INDESIT company

Model type:
LVZ670DUOIX

Commercial code:
F033659

Notices

N1045093FIG1
NEW FLAP UPPER BASKET SAT CODE 114799

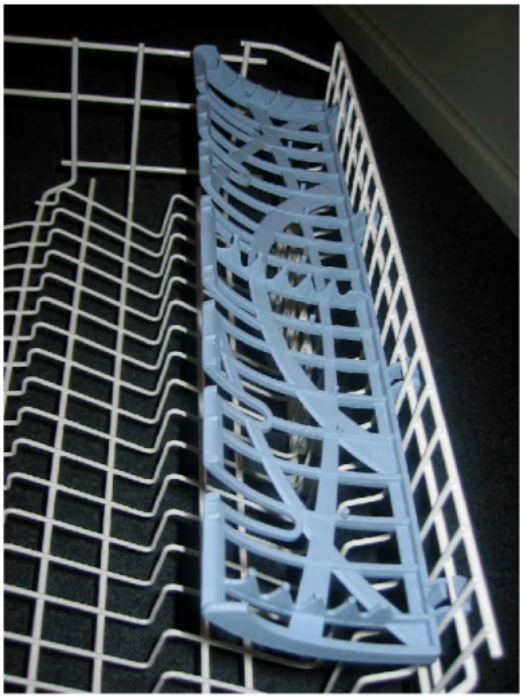
n1045093: Modification of light blue folding shelf attachment.

From serial no. 41109.0001 all models affected by this bulletin feature a modification of the folding shelf to upper basket coupling system.
This modification called for alteration of the relative baskets: the distance between the wire on which the folding shelf is attached and the wire below it has been increased from 9.5 mm to 17 mm, as shown in the attached image.
The altered folding shelves are not interchangeable and cannot be installed on premodification baskets: in the case of service

interventions on product with serial number prior to 41109.0001 the entire upper basket must be replaced.
The baskets are reciprocally interchangeable and are managed as assemblies complete with their accessories, inclusive of folding shelves.

The replacement P/Ns affected by the modification are as follows:

UPPER BASKET LIGHT BLUE FOLDING SHELF
new 114799 - premodification 094140.

UPPER BASKET ASSEMBLIES
new 115001 - premodification 094139;
new 115002 - premodification 094222;
new 115003 - premodification 094233.

N1045076FIG1

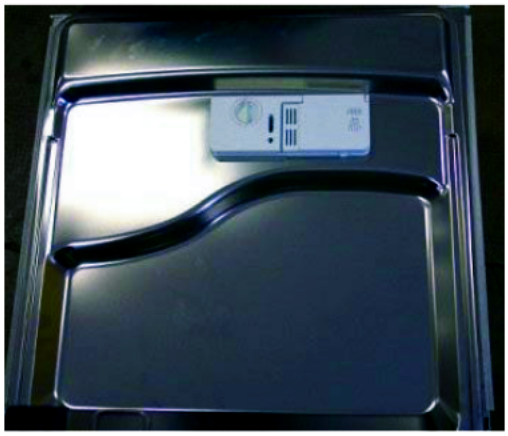
n1045127: New airbreak - solution of water spurts leaking from base LVS 60 CM

From serial number 50930.0001, to solve the problem of water spurts emitted from the lower right and left side of the door the following modifications were introduced in production:

1-Airbreak without insert to allow the necessary pressure venting
2-Honeycomb top panel to protect the kitchen unit from any steam emitted (only on built-under models)
3-Tank seal length increased by 3 cm to improve water tightness
4-Die-cut roof sound-deadening panel
5-Three clips for correct fixing of the tank base seal (in production from serial number 50701.0001)

New parts:
C00141308 - Airbreak
C00141310 - Honeycomb top panel (built-under versions only)
C00141317 - Tank seal
C00141314 - Roof sound-deadening panel
C00140679 - Tank base seal fixing clip

Premodification parts
C00110610 - Airbreak
C00116110 - Tank seal
C00097300 - Roof sound-deadening panel

1) AIRBREAK REPLACEMENT
It is mandatory to use the new part; in the event of replacement with premodification appliances proceed as follows:
- replace the airbreak with the new part C00141308
- if present, refit the roof sound-deadening panel after cutting out a 10x10 cm square from the rear left-hand corner
- on the built-under version, fit honeycomb panel C00141310 on the top of the appliance
- replace tank seal with the new seal P/N C00141317

2) CHANGING THE TANK SEAL
On appliances with serial number from 40101.0001 to 50930.0001, you can use the new tank seal P/N C00141317 after cutting 1.5 cm off each end.
